July 12, 2007

**ADDENDUM NO. 2
FOR THE CONSTRUCTION OF THE
HAPPY HOLLOW PARK AND ZOO
PEDESTRIAN BRIDGE**

Addendum No. 2 - Happy Hollow Park & Zoo- Pedestrian Bridge Package

SHEET NO: SKA2-L1-PB	SHEET TITLE: ADDENDUM #2 LIMITS OF WORK SCALE: AS NOTED DATE: 07/12/07	PROJECT TITLE: HHPZ - PEDESTRIAN BRIDGE 1300 SENTER ROAD - SAN JOSE, CA 95112	THE PORTICO GROUP 	CITY OF SAN JOSE OFFICE OF BROWN FIELD
-------------------------	---	--	-----------------------	---

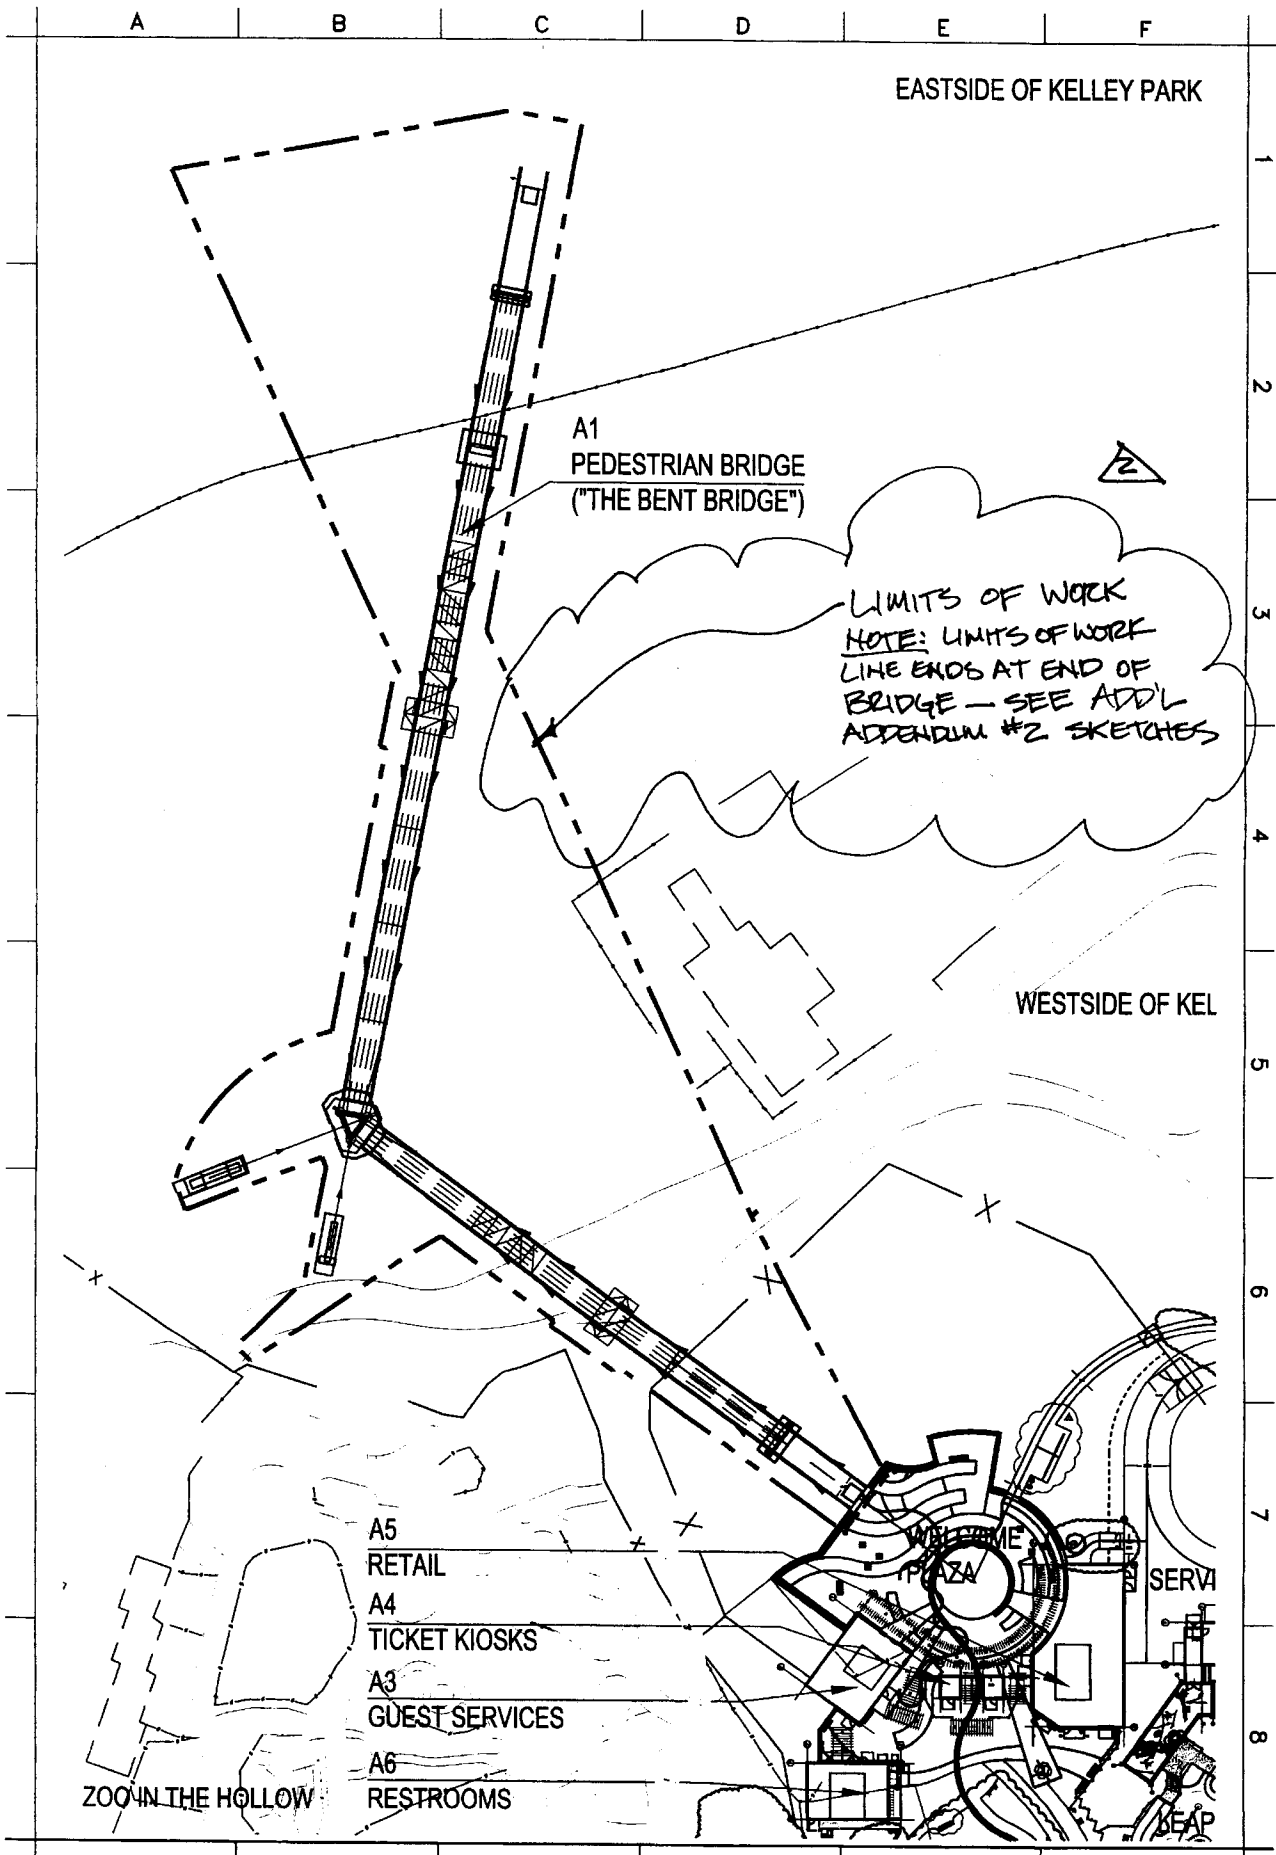
Question #6: Section 8 on Drawing S1.1.15 shows a retaining wall and makes reference to Section 6 on Drawing LA2.11.4. Is this retaining wall within the scope of this contract?

Question #27: Please define the scope of work of this project. Work shown on all civil drawings need to be defined as for reference only unless the work on those sheets is part of the bridge package.

Answer #6: Please see SKA2-L1-PB, SKA2-L2-PB and SKA2-L3-PB showing where the Limit of Work line separates the Pedestrian Bridge from the Welcome Plaza.

Answer #27: Please see SKA2-L1-PB, SKA2-L2-PB and SKA2-L3-PB showing where the Limit of Work line separates the Pedestrian Bridge from the Welcome Plaza.
